Re: Correction Letter
Sonny's Direct
Lee's Summit, MO

Permit No: PRCOM20253506
Project Title: SONNYS
Project Address: 2201 NE TOWN CENTRE BLVD, LEES SUMMIT, MO 64064
Parcel Number: 52500022800000000
Location / Legal Description: TOWN CENTRE LOGISTICS LOT 1 & TRACT A---LOT 1

This is a response to your Plan Review Conditions letter dated 8/29/25

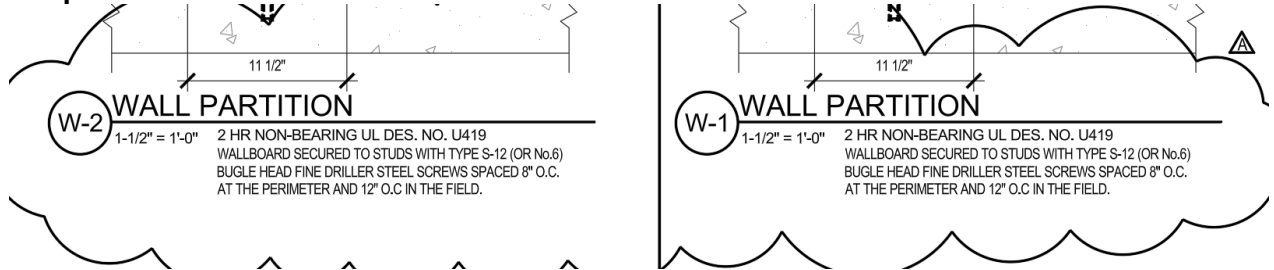
2. 2018 IBC 602.1 General. Buildings and structures erected or to be erected, altered or extended in height or area shall be classified in one of the five construction types defined in Sections 602.2 through 602.5. The building elements shall have a fire-resistance rating not less than that specified in Table 601 and exterior walls shall have a fire resistance rating not less than that specified in Table 602. Where required to have a fire-resistance rating by Table 601, building elements shall comply with the applicable provisions of Section 703.2. The protection for openings, ducts and air transfer openings in building elements shall not be required unless required by other provisions of this code. *Action required: Amend Fire Protection and Life Safety Code Analysis to show correct construction type which is 5B.*

Response: Building Construction Type has been changed to VB

OCCUPANCY CLASSIFICATION:	B_BUSINESS	2,423 S.F.
	H-3 HIGH HAZARD	17,165 S.F.
	S-1 MODERATE HAZARD STORAGE	4,914 S.F.
TENANT AREA (TOTAL):		24,502 S.F.
TYPE OF CONSTRUCTION:	VB 	
NUMBER OF STORIES:	1	
SPRINKLED:	YES (ESFR)	
FIRE ALARM:	YES

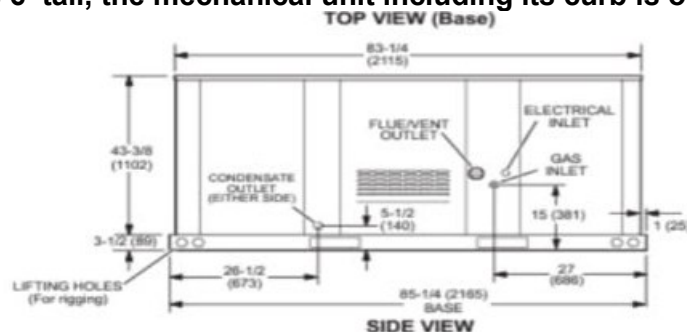
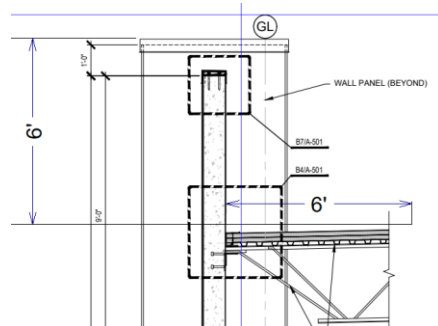
5. 2018 IMC 502.3 Battery-charging areas for powered industrial trucks and equipment. Ventilation shall be provided in an approved manner in battery-charging areas for powered industrial trucks and equipment to prevent a dangerous accumulation of flammable gases. *Action required: Provide exhaust system at battery chargers.*

Response: Exhaust fan EF-2 provides ventilation to battery-charging area within Warehouse 200 and is sized for 1 CFM/SF, which satisfies Code requirements. Louver L-2 is interlocked with exhaust fan EF-2 to open when EF-2 is running. Exhaust fan EF-2 shall draw outdoor air through louver L-2 into Liquid Storage 300 and then the outdoor air will transfer into Warehouse 200 and the battery-charging area via 12' x 14' opening with a 2-hour rated fire door tied to the alarm system. Refer to M2.01 for equipment location. No updates to drawings.
